**SUBDIVISION REVIEW SHEET****CASE NO.:** C8J-2021-0048**PC DATE:** March 8, 2022**SUBDIVISION NAME:** Quad Park 3B-3a Preliminary Plan**AREA:** 26.67 acres**LOT(S):** 63**OWNER/APPLICANT:** Carma Easton , LLC  
(Matthew McCafferty)**AGENT:** Carlson, Brigrance, and Doering, Inc  
(Brett Pasquarella)**ADDRESS OF SUBDIVISION:** Apogee and Skytex**GRIDS:** K11**COUNTY:** Travis**WATERSHED:** N. Fork & S. Fork Dry Creek**JURISDICTION:** Limited Purpose**EXISTING ZONING:** Planned Unit Development (PUD)**MUD PLAN:** Pilot Knob MUD**PROPOSED LAND USE:** Mixed Residential, greenbelt/open space/drainage easement lots, and public ROW**VARIANCES:** None**SIDEWALKS:** Sidewalks will be provided along all internal streets and the boundary street.

# QUAD PARK 3B-3a

## PRELIMINARY PLAN

CITY OF AUSTIN –DEVELOPMENT SERVICES DEPARTMENT  
SUBDIVISION APPLICATION – MASTER COMMENT REPORT

GENERAL NOTES

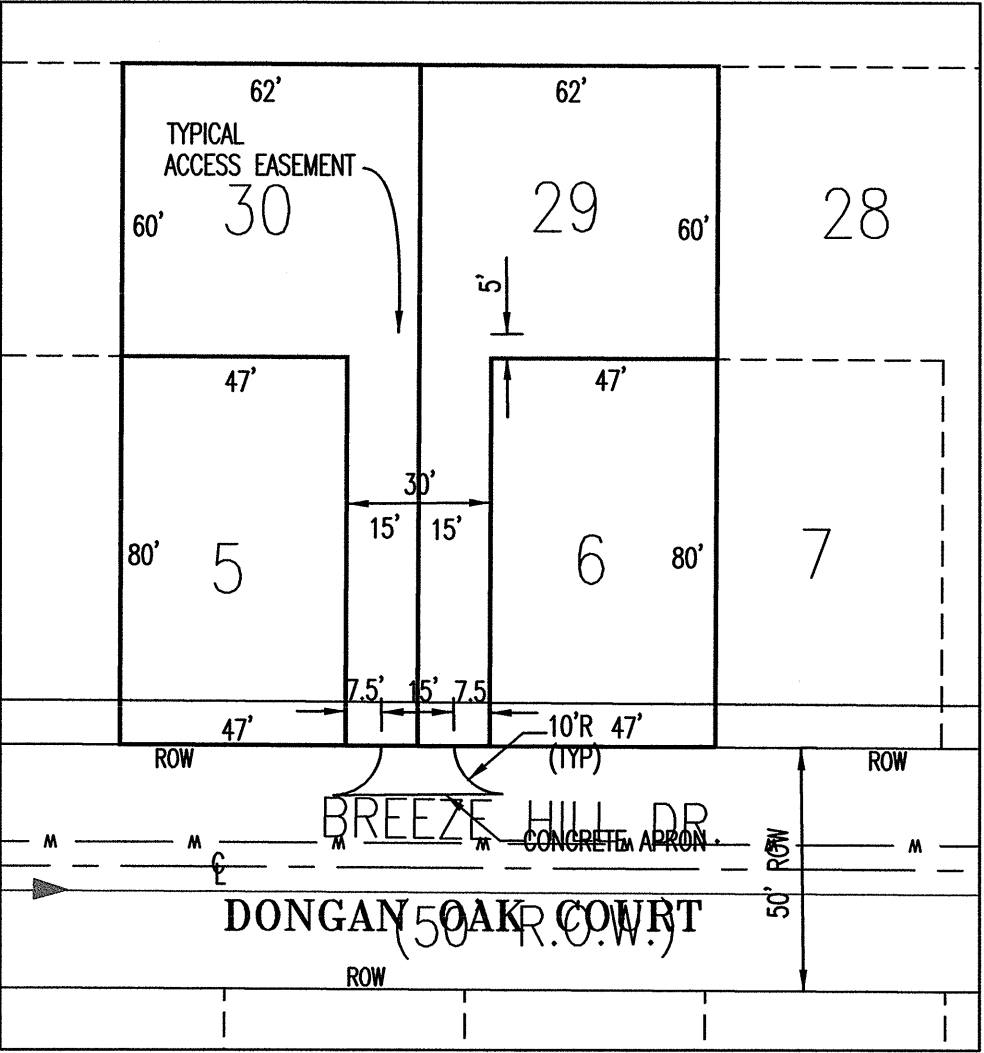
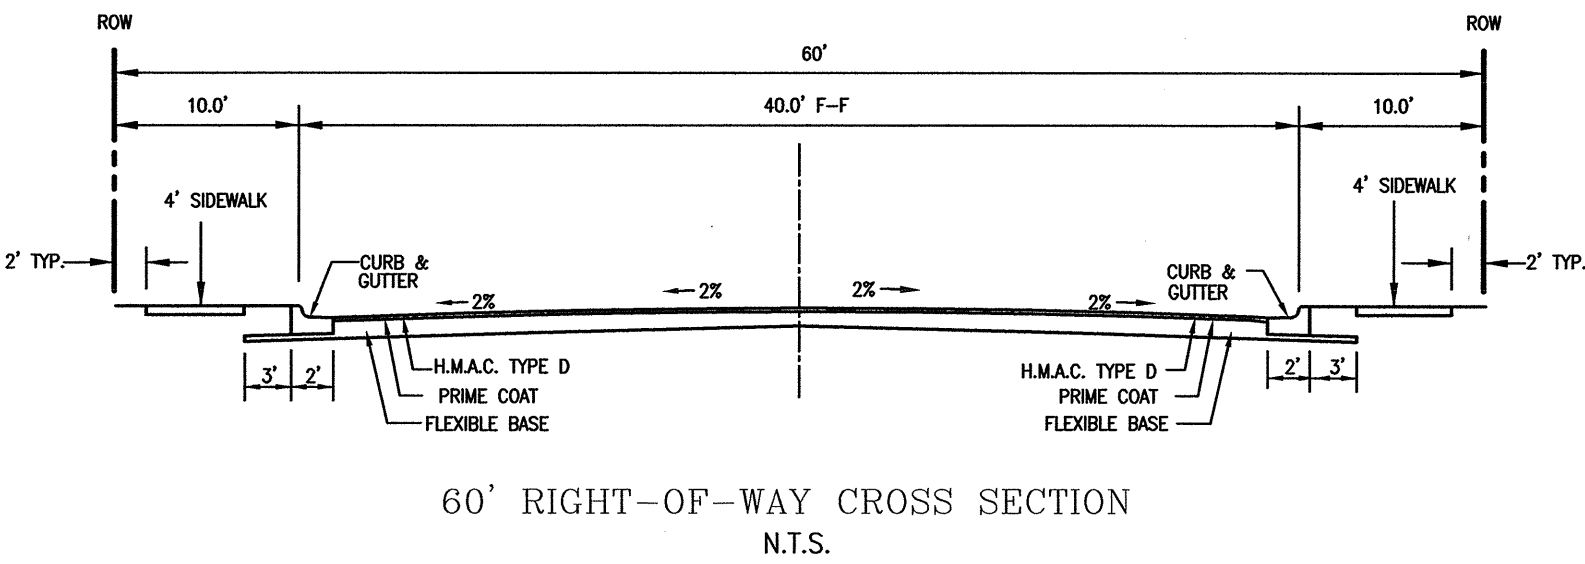
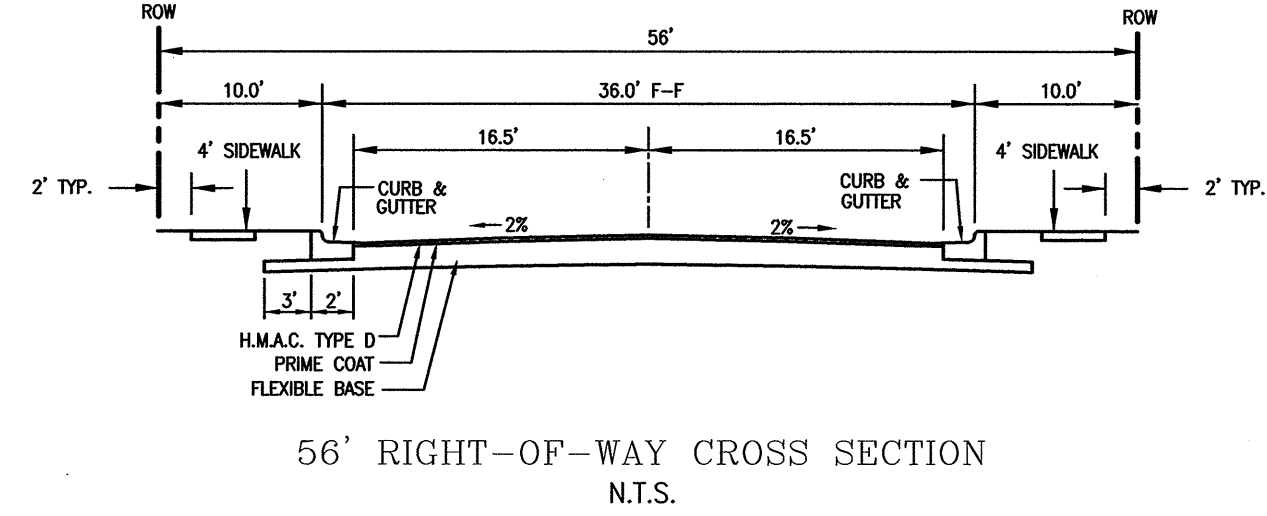
- c. The floodplain note on page 2 states that portions of the lot ARE within the FEMA floodplain, but that is not the case for this lot. Correct as necessary.

PR1: Please update note 10 with the correct lot number (lot 46 A instead of lot 64 A as noted)

SHEET  
PRELIMINARY PLAN (100 SCALE)

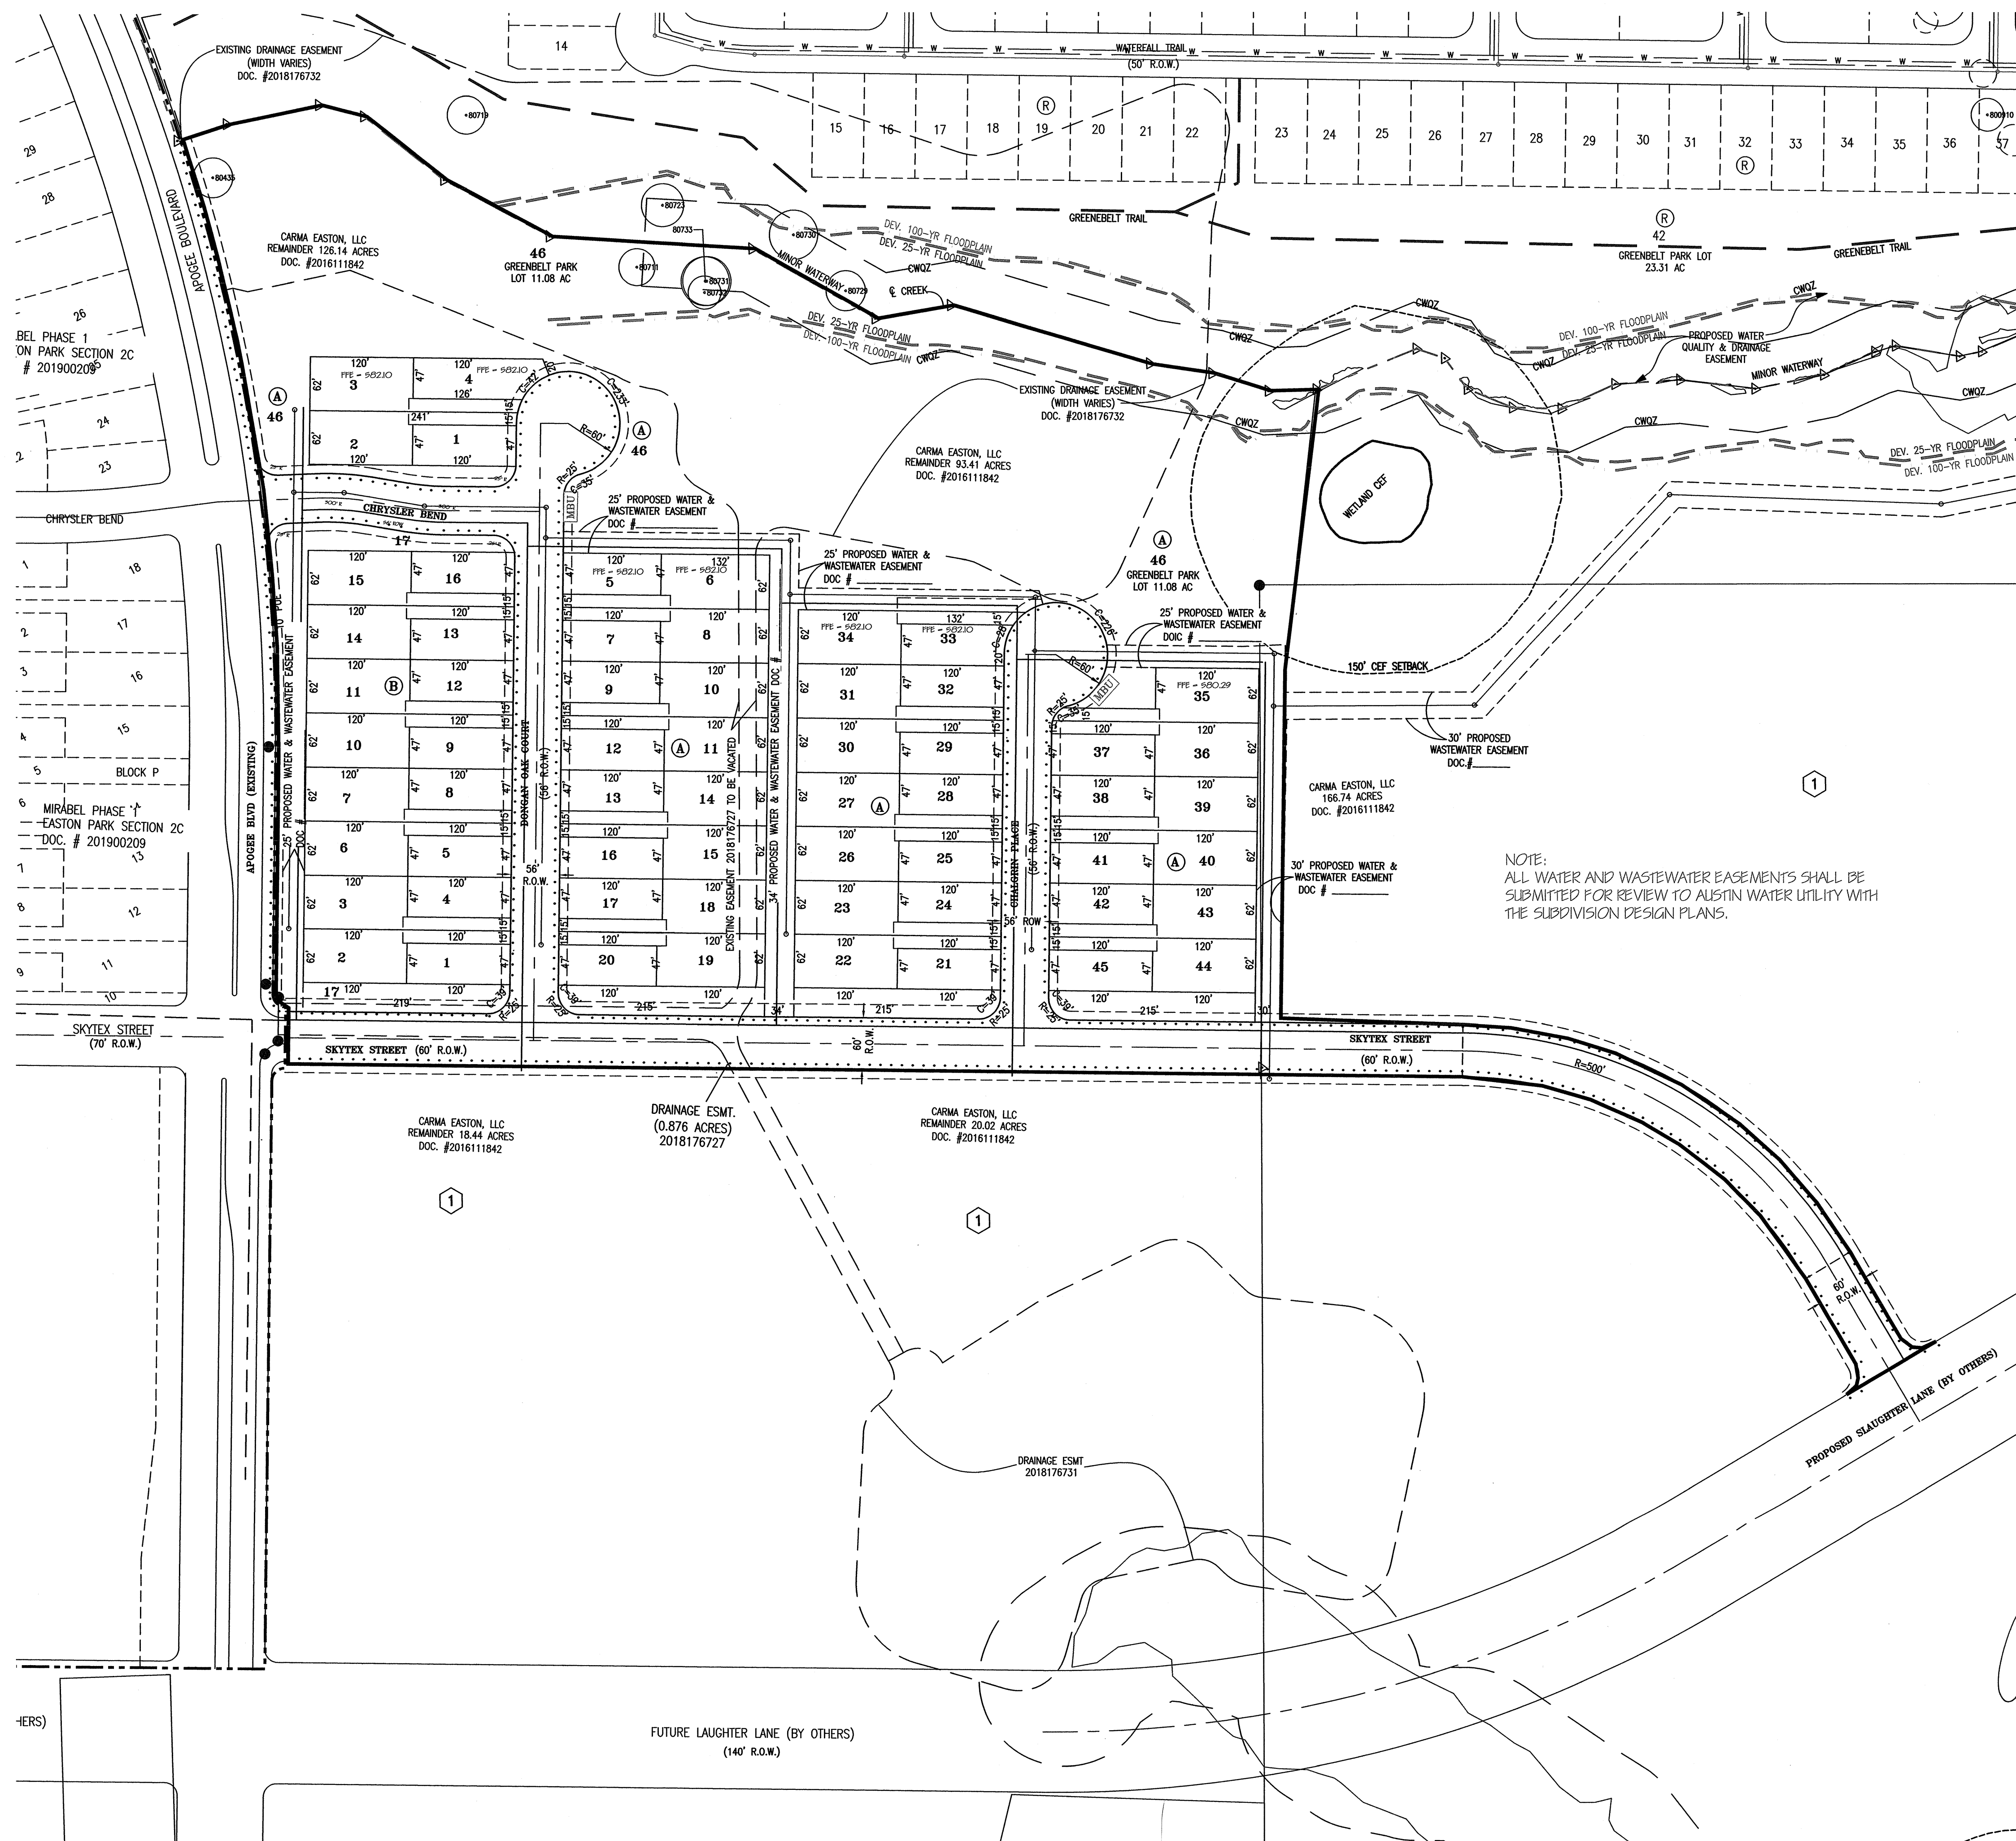
- b. It is unclear that the floodplain downstream of the existing pond is contained to a drainage easement. Floodplain must be contained to a drainage easement. If Lot 46 of Block A is dedicated as drainage easement in addition to Greenbelt Park lot, this will be addressed.

1. Please clearly show boundaries of Lot 46 along Skytex in block A 30-1-113
2. Please correct the typo in the acreage on coversheet. 30-1-113
3. Current tax certificates showing all taxes have been paid for 2021. 30-1-113
4. Verify if this application needs to be signed by two officers of Carma Easton LLC 30-1-113
5. Clearly label the joint access easements on the preliminary and update the exhibit (some overlapping text). 30-2-113 FYI - JUE easements will need to be provided with the plat application.
6. Add a note that Lot 46 and 17 will be owned and maintained by the owner/HOA. FYI - Provide the draft CCR to be recorded with the plat 30-2-113
7. FYI – The Drainage Maintenance Agreement will need to be updated with the final plat.

PR 2: Prelim plan shows parkland lot as 'Greenbelt Park Lot 46 A 11.08 acres'. Table on coversheet has line item: "Greenbelt Park Lots: 2 Total Acres: 10.873". Please reconcile.

- 1) Show the right-of-way width for Chrysler Bend.
- 2) Provide proof from the TIA that Skytex right-of-way is reduced between Apogee and Slaughter.
